Well Name: RIO BLANCO 4-33 FED COM	Well Location: T23S / R34E / SEC 4 / NESW /	County or Parish/State:
Well Number: 7H	Type of Well: OIL WELL	Allottee or Tribe Name:
Lease Number: NMNM092199	Unit or CA Name: RIO BLANCO 4 33 FED COM 1H-3H	Unit or CA Number: NMNM138430
US Well Number: 3002550130	Well Status: Approved Application for Permit to Drill	Operator: DEVON ENERGY PRODUCTION COMPANY LP

Sundry ID: 2670704

Type of Submission: Notice of Intent	Type of Action: APD Change
Date Sundry Submitted: 05/09/2022	Time Sundry Submitted: 10:30
Date proposed operation will begin: 05/09/2022

PECOS DISTRICT DRILLING CONDITIONS OF APPROVAL

Section 2 - Blowout Preventer Testing Procedure

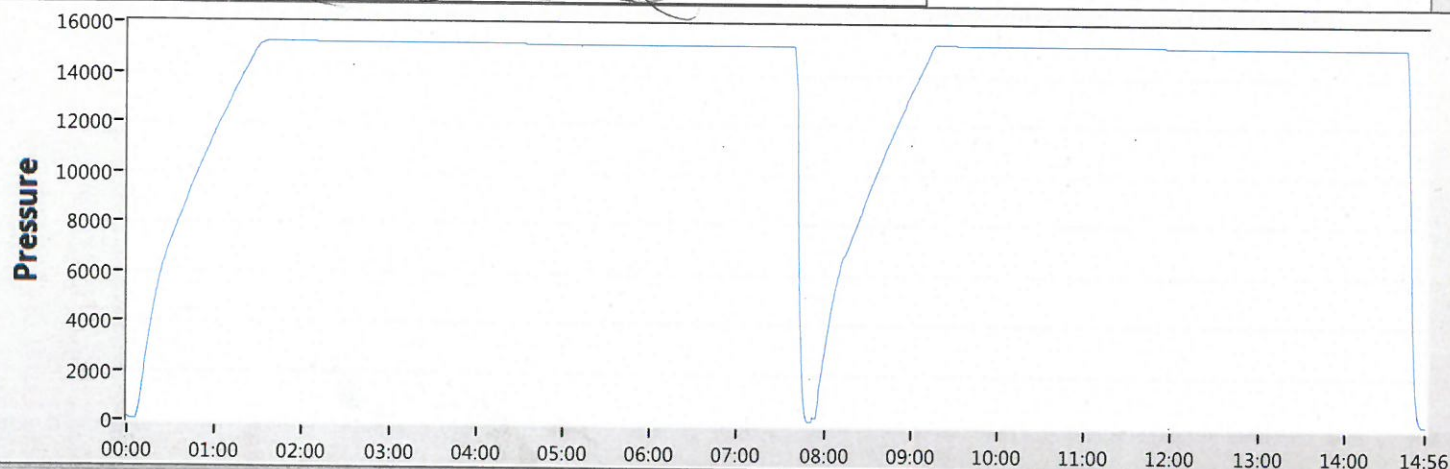
Variance Request

Devon Energy requests to only test BOP connection breaks after drilling out of surface casing and while skidding between wells which conforms to API Standard 53 and industry standards. This test will include the Top Pipe Rams, HCR, Kill Line Check Valve, QDC (quick disconnect to wellhead) and Shell of the 10M BOPE to 5M for 10 minutes. If a break to the flex hose that runs to the choke manifold is required due to repositioning from a skid, the HCR will remain open during the shell test to include that additional break. The variance only pertains to intermediate hole-sections and no deeper than the Bone Springs Formation where 5M BOP tests are required. The initial BOP test will follow OOGO2.III.A.2.i, and subsequent tests following a skid will only test connections that are broken. The annular preventer will be tested to 100% working pressure. This variance will meet or exceed OOGO2.III.A.2.i per the following: Devon Energy will perform a full BOP test per OOGO2.III.A.2.i before drilling out of the intermediate casing string(s) and starting the production hole, before starting any hole section that requires a 10M test, before the expiration of the allotted 14-days for 5M intermediate batch drilling or when the drilling rig is fully mobilized to a new well pad, whichever is sooner. We will utilize a 200' TVD tolerance between intermediate shoes as the cutoff for a full BOP test. The BLM will be contacted 4hrs prior to a BOPE test. The BLM will be notified if and when a well control event is encountered. Break test will be a 14 day interval and not a 30 day full BOPE test interval. If in the event break testing is not utilized, then a full BOPE test would be conducted.

1. Well Control Response:
 1. Primary barrier remains fluid
 2. In the event of an influx due to being underbalanced and after a realized gain or flow, the order of closing BOPE is as follows:
 - a) Annular first
 - b) If annular were to not hold, Upper pipe rams second (which were tested on the skid BOP test)
 - c) If the Upper Pipe Rams were to not hold, Lower Pipe Rams would be third

BOPE Break Testing Variance

- BOPE Break Testing is ONLY permitted for 5M BOPE or less. **(Annular preventer must be tested to a minimum of 70% of BOPE working pressure and shall be higher than the MASP)**

- BOPE Break Testing is NOT permitted to drilling the production hole section.
- Variance only pertains to the intermediate hole-sections and no deeper than the Bone Springs formation.

- While in transfer between wells, the BOPE shall be secured by the hydraulic carrier or cradle.
- Any well control event while drilling require notification to the BLM Petroleum Engineer **(575-706-2779)** prior to the commencement of any BOPE Break Testing operations.

- A full BOPE test is required prior to drilling the first deep intermediate hole section. If any subsequent hole interval is deeper than the first, a full BOPE test will be required. (200' TVD tolerance between intermediate shoes is allowable).

- The BLM is to be contacted **(575-689-5981 Lea County)** 4 hours prior to BOPE tests.
- As a minimum, a full BOPE test shall be performed at **14-day** intervals.

- In the event any repairs or replacement of the BOPE is required, the BOPE shall test as per Onshore Oil and Gas Order No. 2.
- If in the event break testing is not utilized, then a full BOPE test would be conducted.
